## Subject: PSEG Early Site Permit Application Docket No. 52-043 Response to Request for Additional Information, RAI No. 41, Stability of Subsurface Materials and Foundations

#### **RESPONSE to RAI No. 41**

## Response to RAI No. 41, Question 02.05.04-7:

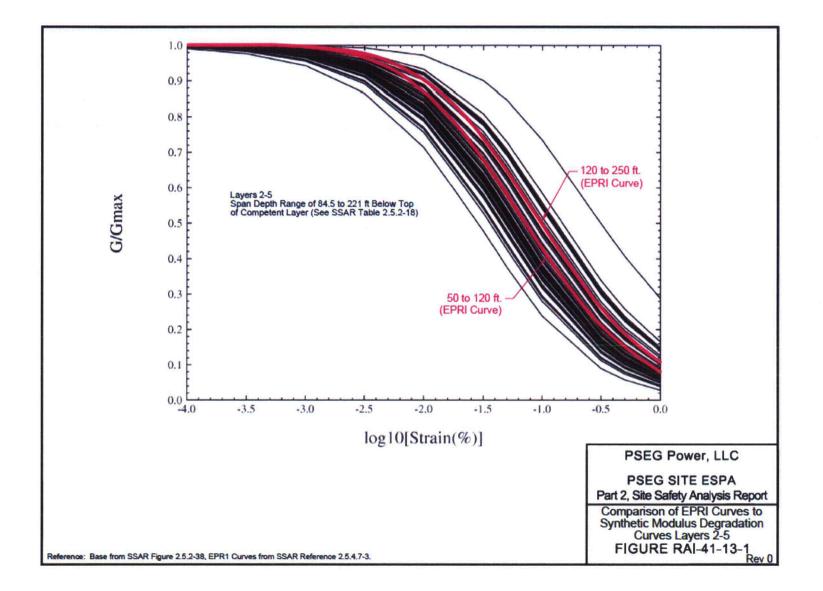
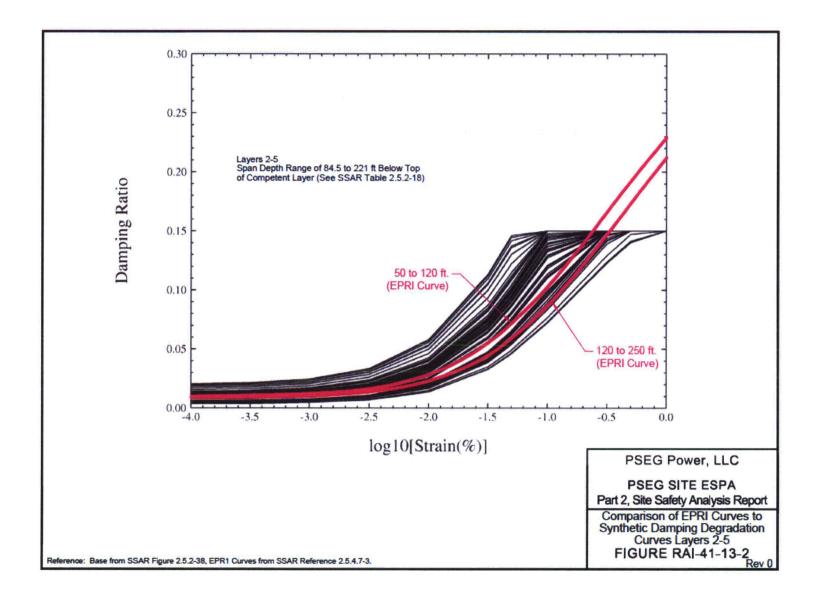
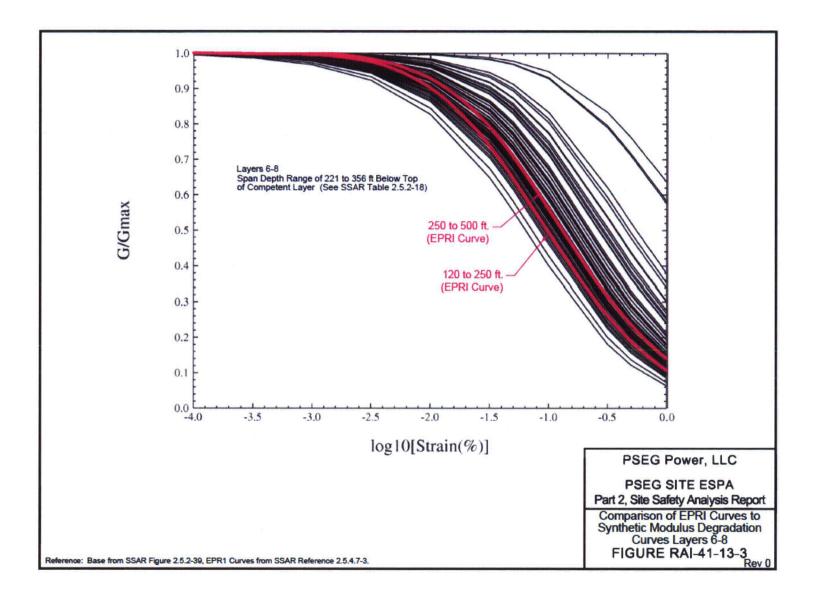
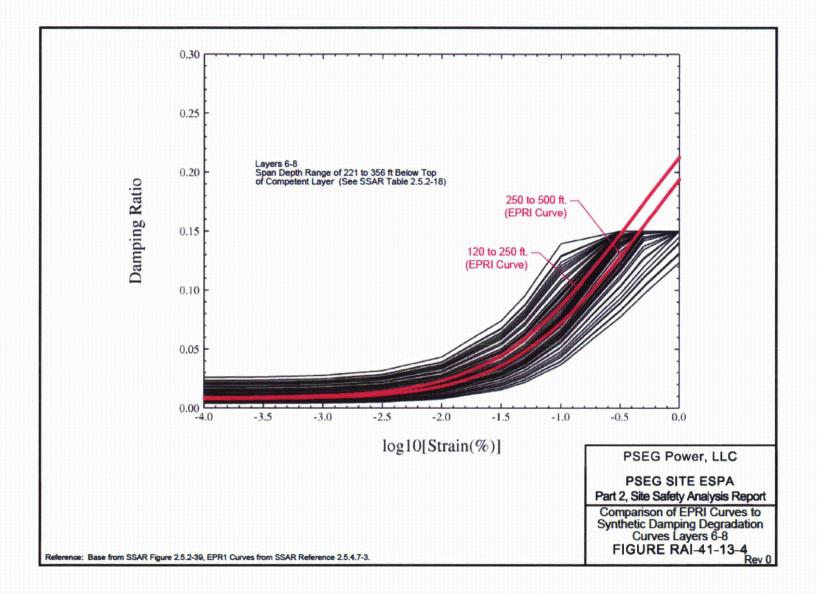
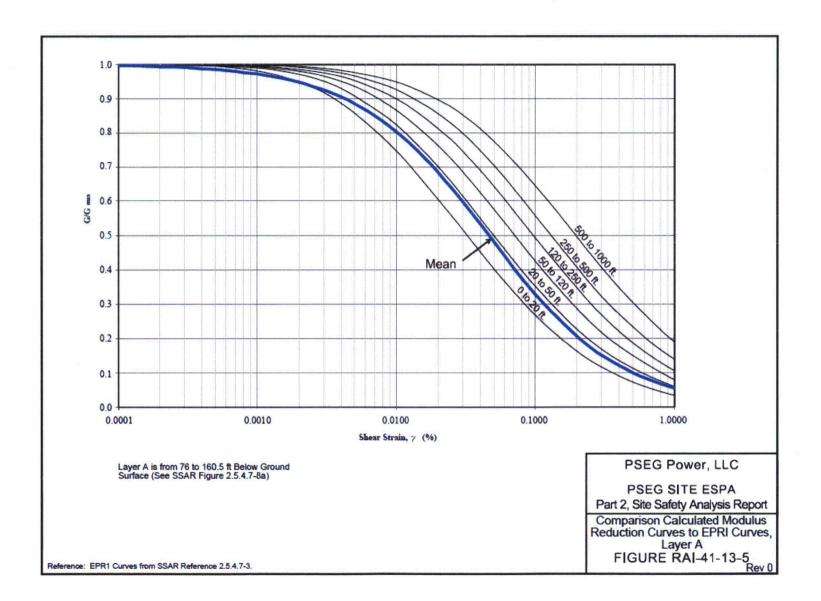
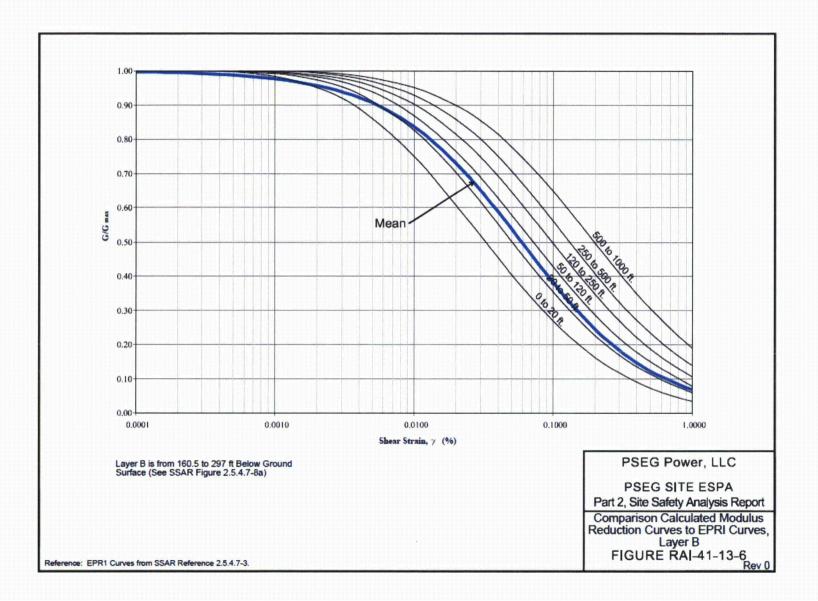
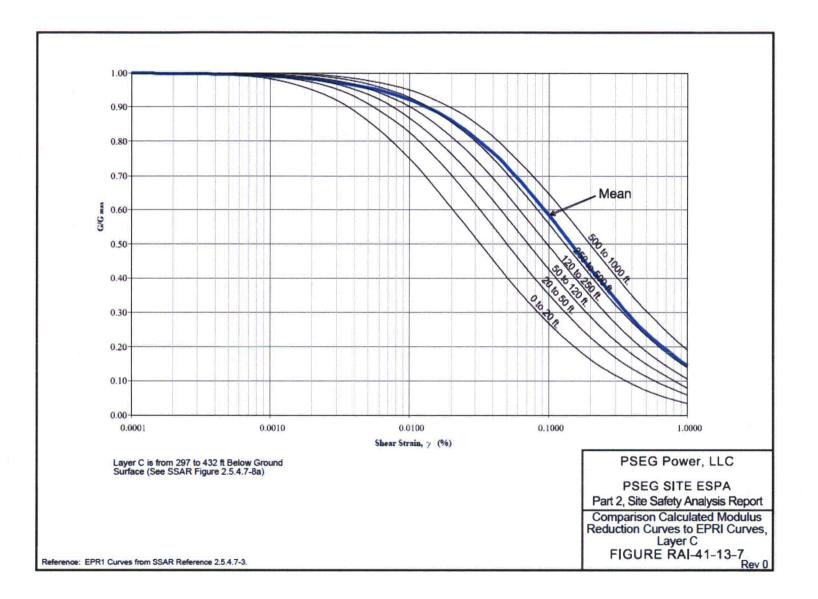
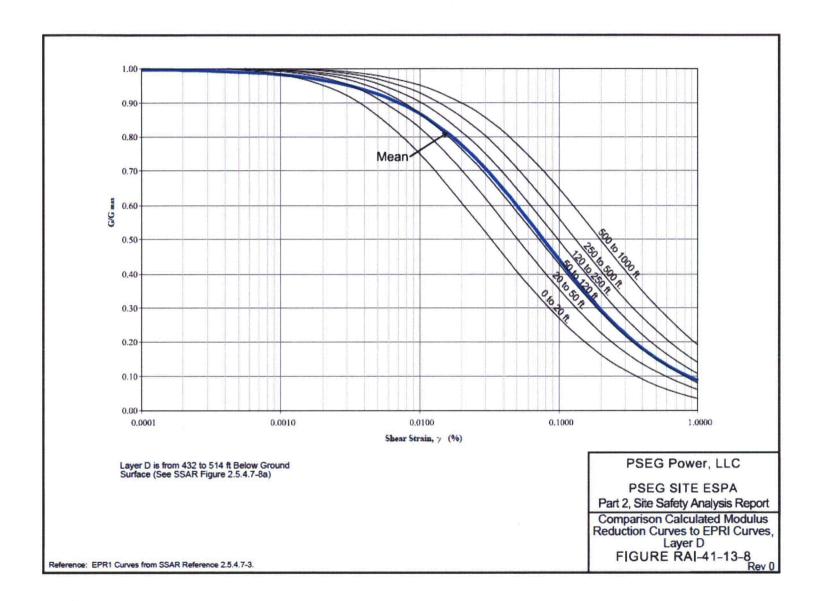
SSAR Section 2.5.4.7.5 indicates that the applicant did not use RCTS test results to characterize the degradation property of foundation bearing soils because of sample disturbances of the cemented soil layers. Darendeli equations were instead used to estimate modulus reduction and damping variation with shear strain. In compliance with 10 CFR 100.23 (d) (4) and in conformance to NUREG-0800, Standard Review Plan, Section 2.5.4, "Stability of Subsurface Materials and Foundations," please justify the validity of such equations and how they could represent actual degradation properties of the soils at the site, and discuss whether it is a conservative approach when used in site seismic response analysis.

The equations to produce modulus reduction and damping variation with shear strain used in the SSAR (Darendeli equations) were the result of research work at the University of Texas under the direction of Dr. Ken Stokoe. The validity of these equations is supported by comparisons with data from the DOE Savannah River Site as reported in SSAR Reference 2.5.4.7-10. The subsurface conditions at the Savannah River Site are similar to those at the PSEG Site, consisting of layered Tertiary and Cretaceous sediments.

The results of the RCTS testing on samples from the Vincentown, Hornerstown, and Navesink Formations at the PSEG Site, as discussed in SSAR Subsection 2.5.4.7.5, were interpreted as inconsistent and potentially affected by presence of cemented layers. There are no other data on degradation and damping variation characteristics of the site soils available. Based on the general similarity of subsurface soil types at the PSEG Site and the Savannah River Site and the successful use of the Darendeli equations with those soil types, use of the calculated curves is a reasonable approach to representing degradation properties of the soils at the PSEG Site.

The calculated curves were used in conjunction with other factors to develop 60 synthetic profiles for use in the GMRS analysis as described in SSAR Subsection 2.5.2.5.2.1. The synthetic profiles are shown in SSAR Figures 2.5.2-38 and 2.5.2-39. The plots on those figures have been separated into Figures RAI-41-13-1 through RAI-41-13-4 and the EPRI generic curves for the appropriate depth range of the layers on the SSAR figures have been overlaid. As can be seen, the EPRI curves are within the range of the synthetic profiles.

The calculated degradation curves were also used in calculating an elastic modulus for the settlement analysis as described in SSAR Subsection 2.5.4.10.3. As shown in Figures RAI-41-13-5 through RAI-41-13-8, the mean lines of the calculated degradation curves are either slightly lower than the generic EPRI curves for the layer depth range,

or in the case of Layer C, approximately in the same position. This indicates that elastic modulus values computed using the generic EPRI curves would be equal to or greater (stiffer) than those from the calculated curves used to develop the SSAR settlement estimates. Thus, using the values developed from the calculated curves, the settlement is equal to or greater than it would be using the EPRI curves - a conservative approach.
